### **Addendum 13: Global technical regulation No. 13**

#### **Global technical regulation on hydrogen and fuel cell vehicles**

Established in the Global Registry on 27 June 2013

[Figure X: Relationship between the initial burst pressure and end-of-life burst pressure \(estimated\)](#)

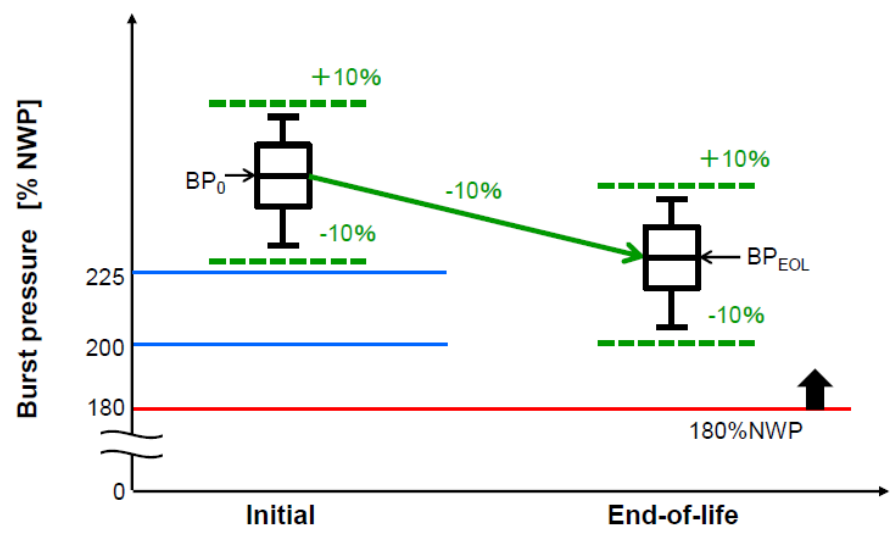
[In subsequent discussions of Phase 2, Japan presented data from experiments using carbon-fibre composite containers for 70 MPa, to support the minimum initial burst pressure change from 225 per cent NWP to 200 per cent NWP for carbon fibre containers only \(Tomioka, J. et al. \(2019 September\). "Influences of Hydraulic Sequential Tests on the Burst Strength of Type-4 Compressed Hydrogen Containers." 2019 International Conference on Hydrogen Safety. Technical Paper ID 159.\). Note, the requirement for glass fibre containers remains unchanged at 350 per cent NWP.](#)

[The relationship between the current initial burst pressure requirement and the estimated end-of-life burst pressure requirement is shown in Figure X. The Japanese experiment showed that containers which met the  \$BP\_0 \pm 10\$  per cent requirement and subjected to the hydraulic sequential tests, were able to meet end-of-life burst pressure of at least 180 per cent NWP, even if the minimum initial burst pressure is reduced to 200 per cent NWP.](#)

Figure XX: Results from verification test

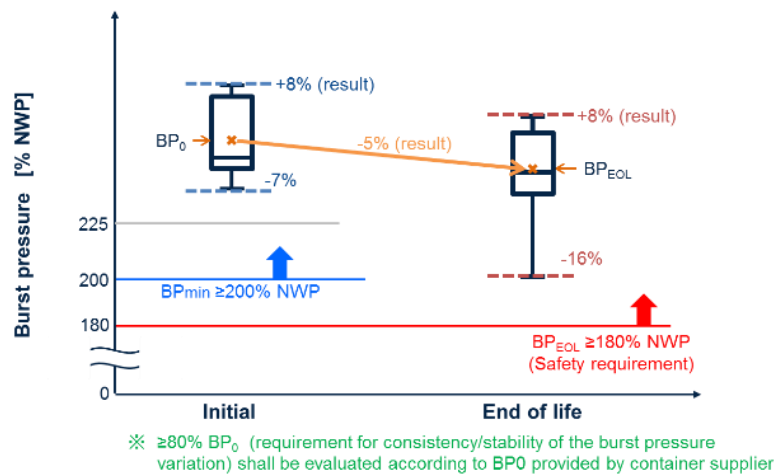
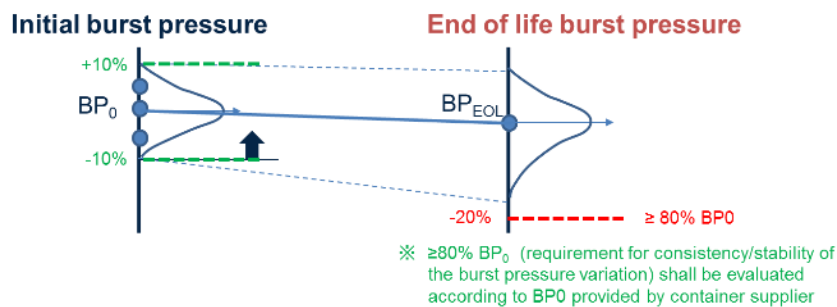
The test results are shown in Figure XX. The minimum value of the initial burst pressure was greater than 225 per cent, and within the  $\pm 10$  per cent of  $BP_0$  requirement. The end-of-life burst pressure, which takes into account the variation and degradation ratio due to testing, was greater than 180 per cent NWP. It was also greater than 80 per cent of  $BP_0$  by a sufficient margin (Figure XXX).

The results show that the minimum initial burst pressure of 225 per cent NWP can be reduced to 200 per cent NWP while maintaining end-of-life burst pressure ( $BP_{EOL}$ ) above 180 per cent NWP and 80 per cent of  $BP_0$  requirements.

However, in Phase 2 discussions, another Contracting Party stated that the data to change the initial burst pressure requirement of the containers for 35 MPa is not sufficient. Therefore, the requirement value for the carbon-fibre composite containers for 35 MPa was left at 225
